**PERMIT**  
**SEWAGE DISPOSAL SYSTEM**  
HOWARD COUNTY HEALTH DEPARTMENT  
BUREAU OF ENVIRONMENTAL HEALTH  
410-313-2640

ADDRESS 1835 West Old Liberty Road, Westminster, MD 21157 PHONE 410-875-2400

SUBDIVISION Scotts Delight LOT NUMBER 2 ADDRESS 1300 St. Michaels Road

NOT TO SCALE

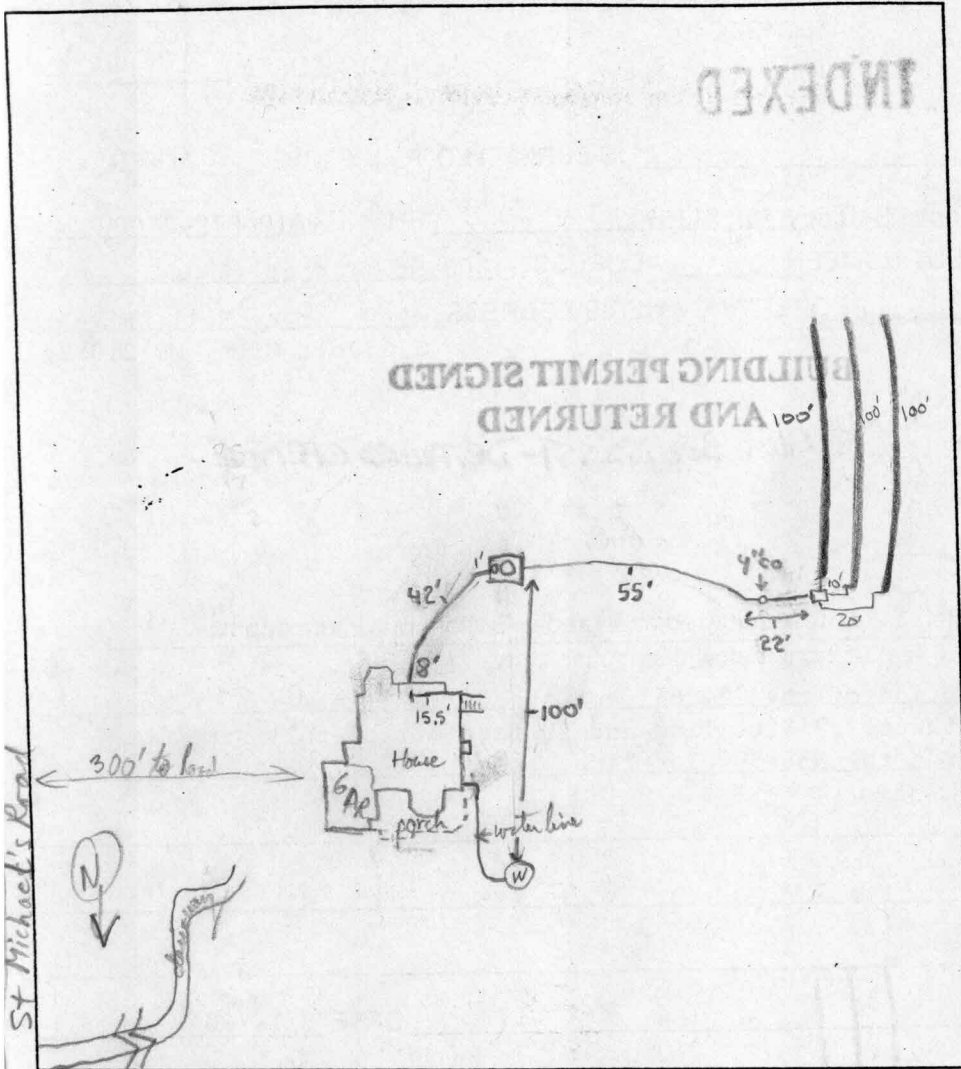
PRE-CONSTRUCTION INSPECTION: 2/21/01 - WENT OVER INSTALLATION WITH INSTALLER, OK TO BEGIN WORK, TRY TO MAINTAIN 10' CENTER TO CENTER BETWEEN TRENCHES, BOTTOM TRENCH MAY BE SLIGHTLY WIDE IN ORDER TO SAVE TREES BUT OK IF SLIGHTLY WIDE (SRK)

INSPECTION COMMENTS: 2/26/01 A.M. FINAL INSP - OK TO COVER ALL SEPTIC WORK. DKC
